UNITED STATES PATENT AND TRADEMARK OFFICE

10/826,684

Office Action Summary

DETAILED ACTION

Figure 1 (taken from '166)

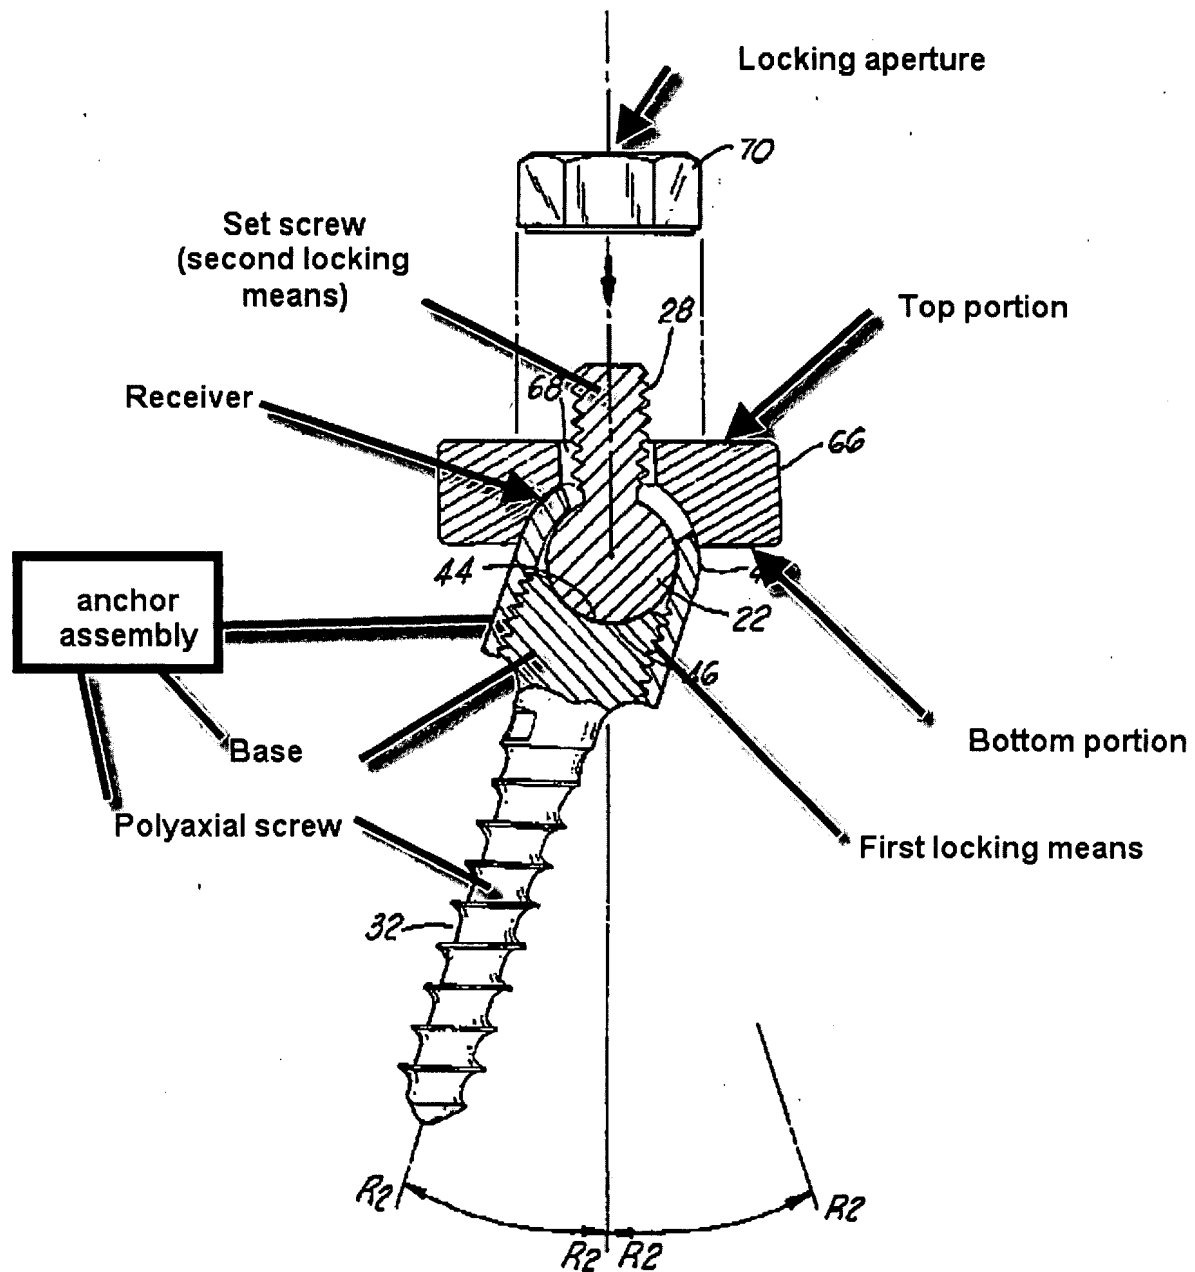
Bernhardt et al. disclose an elongate plate support element with a top portion and a bottom portion having a bottom surface and on or more apertures passing therethrough that spans two or more vertebrae (Fig. 1). The bottom surface includes a receiver configured to receive a plurality of anchor assemblies wherein the anchor assemblies includes a means for locking the anchor assembly to the bottom portion of the support element. The means for locking includes a locking aperture. Also disclosed is a base (pedicle screw) having a head and a means for locking the base to the anchor assembly, such that when assembled, the anchor assembly does not pass through the support element. **(See Figure 1 below)** The base is comprised of a base head wherein the base head is movably disposed within the anchor assembly. The base head is consisting of a polyaxial connector and can be locked in a desired position.

One or more apertures have dimensional configuration providing access to the base and the means for locking the base to the anchor assembly through the top portion of the support element, wherein the head of the base for the anchor assembly does not pass through the support element. The apertures (14), as seen in Fig. 1 of '166, provide this access. The anchor assembly can have a 90-degree twist on configuration depending on its application. The receiver is integrally disposed and attached within the bottom surface of the bottom portion of the support element having a configuration of a slot. The receiver or access ports spans the length of the bottom surface and is comprised of two closed ends. The means for locking the anchor assembly to the support element includes a setscrew (28) disposed within the locker aperture of the nut (70), wherein the screw and locker aperture are threaded.

Bernhardt et al. also disclose a methods of implanting a plurality of anchor assemblies having bases into the bone with a first and second locking means (see Figure 1 above), connectively positioning a support element with a receiver, locking the bases within the anchor assemblies and locking the anchor assemblies within the support element receiver, where the anchor assemblies do not pass through the support element. The support element is disposed within a body location such as subcutaneous fat layer of the spine. It also can be viewed that the support element is disposed external to the body when the surgery is taking place.
